Kentucky Power Company
KPSC Case No. 2018-00209
Commission Staff's Second Set of Data Requests
Dated October 17, 2018

KPSC 2-3 State whether Kentucky Power contends that the Enterprise Park Economic & Area Improvements Transmission Project, as defined in its application, would be necessary to serve Kentucky Power's current and projected customers in the event that the Enerblu, Inc., manufacturing campus was not being constructed in the Kentucky Enterprise Industrial Park.

Sendelbach Family Trust Map

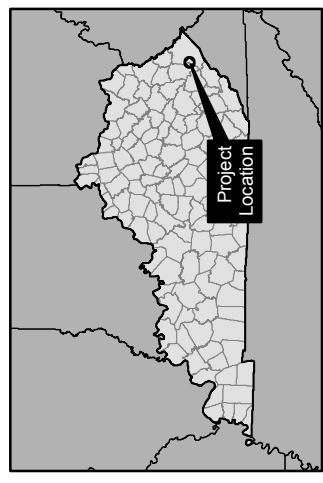
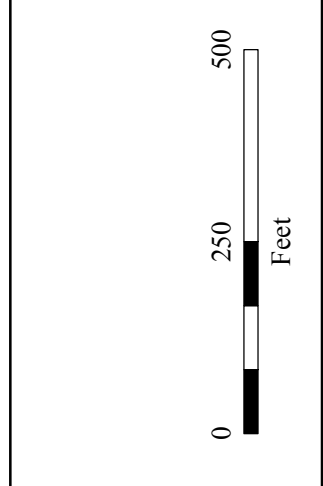
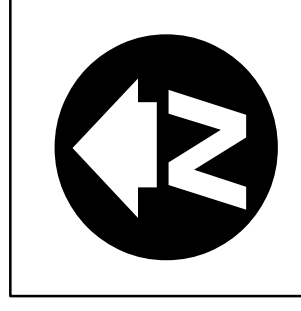
- a. State whether the property identified as "24" on the maps on pages 1 and 2 of Exhibit 3 is the property identified in Exhibit 11 as "PSC Filing ID 24."
- b. Describe how the property boundaries as shown on Exhibit 3 were determined.
- c. State whether the proposed route for the transmission line would cause the transmission line or the right-of-way for the transmission line to cross the property identified as "24" assuming there is no need to relocate the line within the filing corridor.
- d. Describe the portion of the property identified as "24" in Exhibit 3 that is within the filing corridor.
- e. Describe the circumstances, if any, under which the proposed transmission line or right-of-way for the transmission line would cross the property identified as "24" in Exhibit 3.

c. The centerline shown on Exhibit 3 in the vicinity of parcel "24" would not have crossed parcel "24" based on the boundaries provided by the Pike County PVA office. Prior to filing Kentucky Power agreed with the property owner to relocate the centerline 300 feet to the south to the position indicated on Exhibit 3 to avoid crossing parcel "24."

Kentucky Power conducted a ground survey in the vicinity of parcel 24 subsequent to filing the application and determined that the boundaries provided by the Pike County PVA are inaccurate. Based on the revised boundaries determined by the ground survey the center line will cross approximately 200 feet of the parcel near its southern edge.

e. Please see the Company's response to subpart (c). Approximately 200 linear feet of the 100-foot right-of-way (ROW) (0.45 acres) will cross the Sendelbach property.

Structure 8 will be located on the southwestern tip of parcel "24" on a predominant ridge between two valleys. Structure 8 will be required to be approximately 140 in height to support a 3,350 foot back span and 3,500 foot ahead span over the two valley bottoms (KPCO_R_KPSC_2_7_Attachment1).

KPCO_R_KPSC_2_7_Attachment1.pdf shows the ground surveyed parcel boundaries, compared with the information received from the PVA office, which was displayed on Exhibit 3.

3D View Looking West
Structure 8

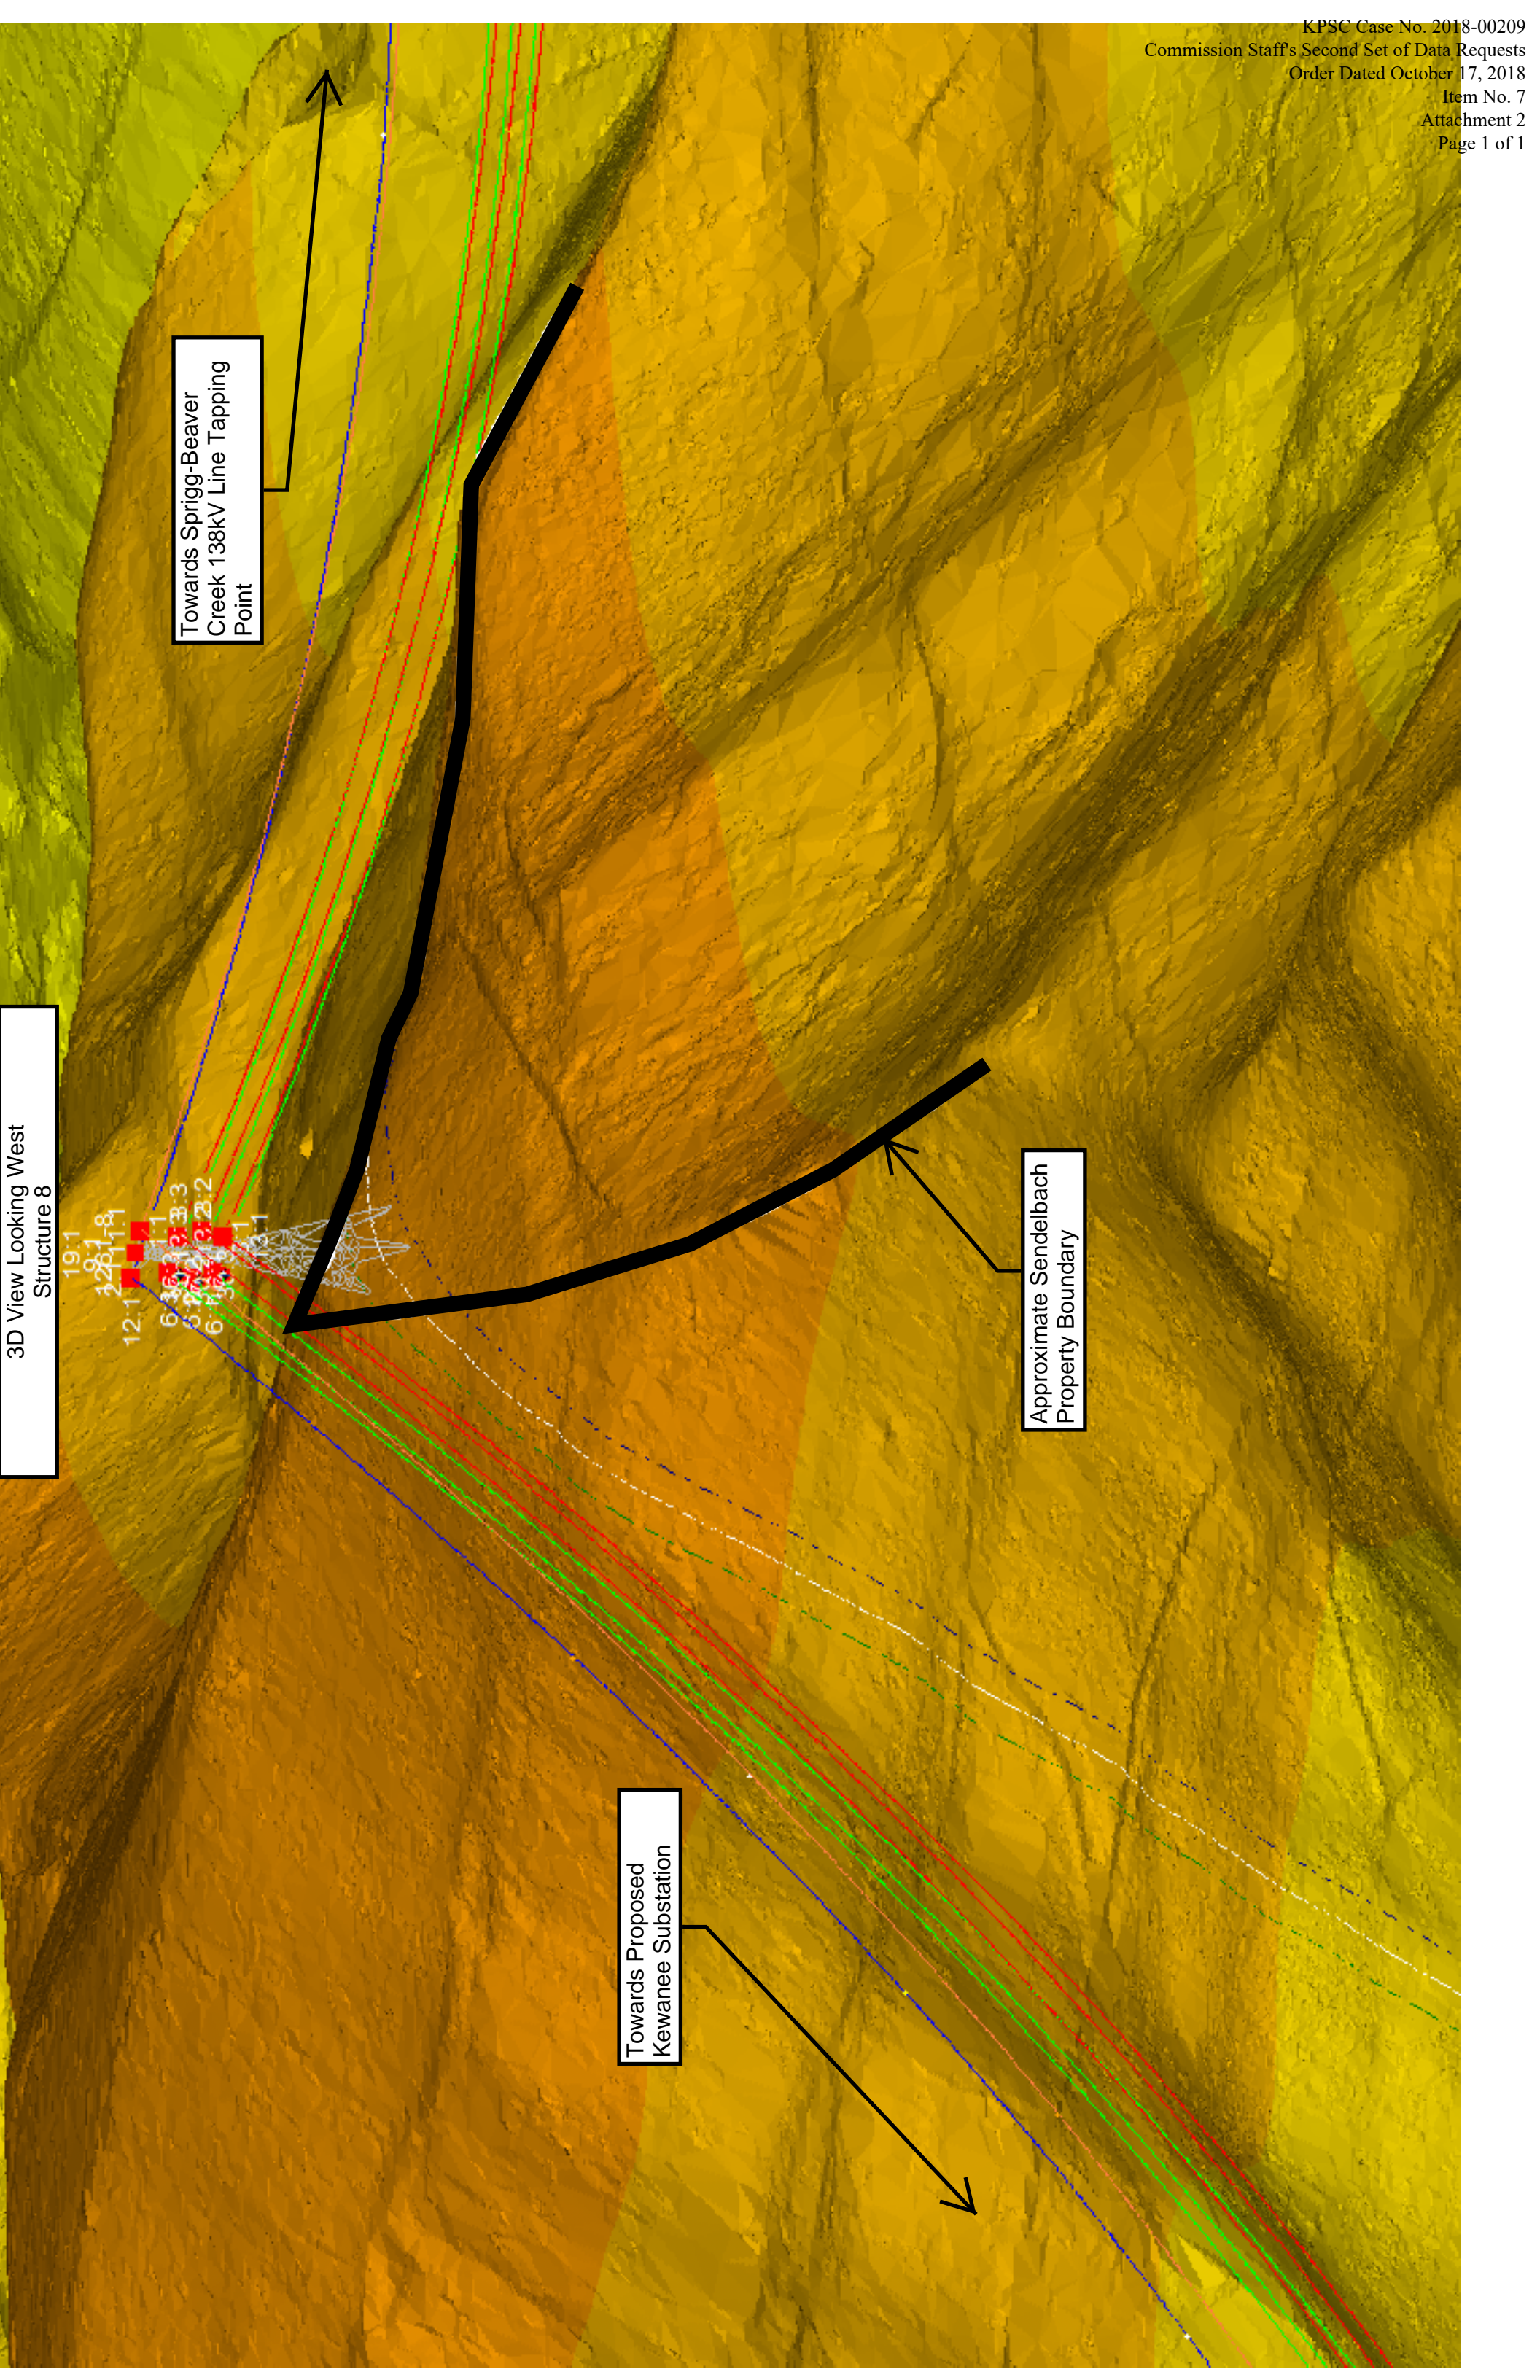
- a. State whether Kentucky Power anticipates that it will need to construct either service roads or access roads to construct the transmission line portion of the project.
- b. If not, state how it anticipates accessing the proposed site for construction and service.
- c. If so, describe all service and access roads it anticipates constructing, and state whether the estimated cost for the construction of those service and access roads is included in the estimated cost of the Enterprise Park Economic & Area Improvements Transmission Project.
- d. State whether any service or access road will be constructed on the property identified as "24" on Exhibit 3 to the application.

Kentucky Power representatives met on October 24, 2018 with Mr. Gary Bishop. Mr. Bishop is associated with parcel "24." At that meeting, Kentucky Power representatives used mapping to update Mr. Bishop on the proposed ROW location, which clips the southern edge of the property, and explained the PVA parcel information was updated with a ground survey. Mr. Bishop asked if the ROW could shift farther to the south and off the Sendelbach property. Kentucky Power representatives indicated that although further investigation concerning route modifications would be undertaken, the location of the ROW and Structure 8 is not anticipated to change because of the topographic and land use constraints (KPCO_R_KPSC_2_7_Attachment2).

Kentucky Power engineers subsequently investigated moving the center line and accompanying ROW farther south on the ridge to avoid parcel "24." Topographical constraints and land use conflicts on Left Fork Island Creek Road make relocation farther to the south impracticable. Specifically, shifting Structure 8 farther south on the narrow ridge would move the ROW closer to a cemetery and residential building, shown as parcels 18 and 19 on KPCO_R_KPSC_2_7_Attachment2.pdf. The Company will continue working with Mr. Bishop and the Sendelbach Family Trust to extent practicable and plans to visit the Sendelbach Family property in the near future to evaluate the views from Sendelbach home located on Left Fork Island Creek Road toward Structure 8.

d. An access road will be built to structure 8 from the south. A temporary construction pad around structure 8, that will also encompass the approximately 45 foot temporary access road to be constructed on parcel "24," will be required to provide a work space to erect the structure (see KPCO_R_KPSC_2_7_Attachment2).
